**State of Vermont Department of Health**

**Radioactive Materials Program**

**Procedure 2.5, Revision 0**

**Enforcement, Escalated Enforcement, and Administrative Actions**

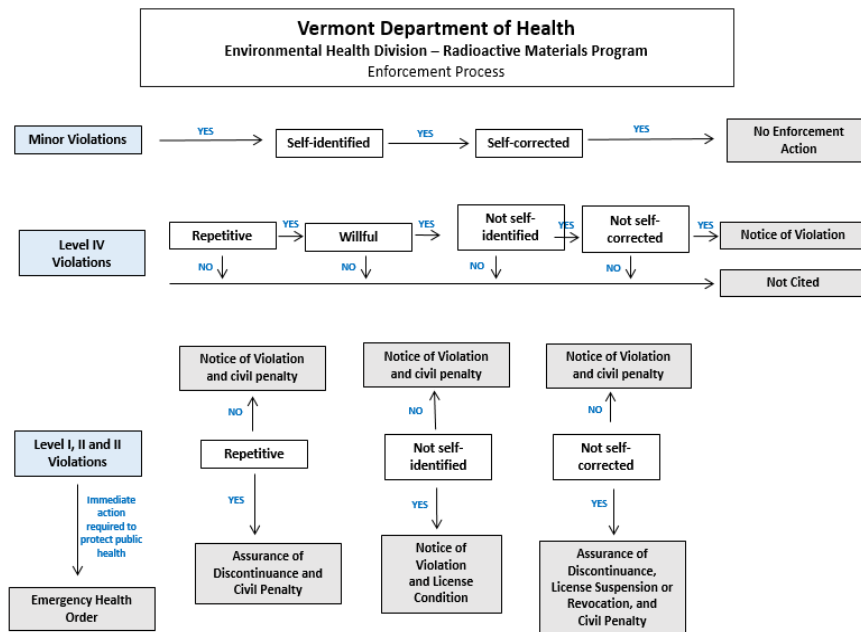
**Commented [SJ40]:** This chart should be revised as follows:

- The “not self-identified” boxes are confusing because of the double negative. Suggest that VT make all those boxes “self-identified” like the minor violations flow chart path.

-Suggest revising the “not self-corrected” boxes to “self-corrected” for the same reasons—i.e., the double negative is confusing.

-There is a typo in the “Level, I, II, and III Violations” box—II is listed twice.

-To model the NRC’s enforcement program, willfulness (i.e., careless disregard OR deliberateness) should play a role in the SL I-III violations. The NRC may escalate if willfulness is involved – e.g., a willful SL IV can become an SL III.
